Interactive comment on “Time-series analysis of the long-term hydrologic impacts of afforestation in the Águeda watershed of North-Central Portugal” by D. Hawtree et al.

D. Hawtree et al.

Received and published: 31 December 2014

Fig. 1.

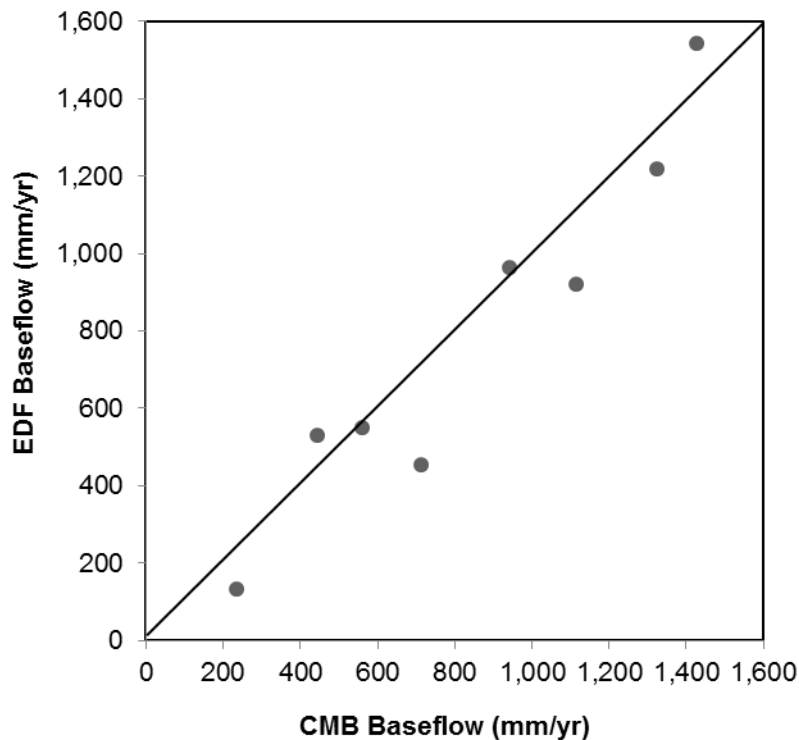
2. “The interpretation of the baseflow trends needs further consideration. A recent paper in HESS by Cartright et al. (2014) is pertinent. For the watershed analysed by Cartright et al., they showed that estimates of baseflow from the local minimum and recursive digital filters (including the Eckhardt filter adopted by the authors) are higher than those based on chemical mass balance using Cl calculated from continuous electrical conductivity measurements. This suggests that baseflow computed using a digital filter is made up of local riparian groundwater (including bank storage) that has a short storage delay time plus the more regionally based groundwater with a much longer storage delay time. The interplay between these two baseflow components may explain some of the features of the BFI trends observed in Figure 6. I would suggest the authors examine this aspect in relation to the Águeda watershed.”

3 can be considered, where the y-axis is the output from the Eckhardt digital filter (EDF Baseflow) and the x-axis is the Conductivity Mass-Balance (CMB Baseflow). The overlain black line is the one-to-one line. For the annual time scale the correlation 0.958 (figure 1), the monthly was 0.956 (figure 2).

This plot reveals that there is a greater difference in the estimates during the drier months (as compared to all months) although the Pearson's correlation coefficient of 0.83 still indicates a high level of correlation. As can be seen in the plot, the reduced correlation appears to be primarily due the higher estimates produced by the CMB method.

two methods, and there are indications of a positive bias of the CMB method during low months, and from this analysis, we cannot assess which method provides a more accurate estimate of BFI. However, for the purposes of this study, the accuracy of the method of estimating the BFI is a secondary consideration to the data availability to utilize an approach, and the stability of the estimations from the method selected. As the CMB data is only available for a short period of time, relative to the 75 year period being considered, it is not a viable method for conducting the trend tests needed for this study. By contrast, the EDF method provides a consistent method of estimating the baseflow across the entire 75 year period, since it is strictly based on the hydrograph data. Therefore, while a chemical mass balance approach (such as that tested by Cartright) may provide a more accurate baseflow ratio, there is no data available to support this method over the data period considered in this study.
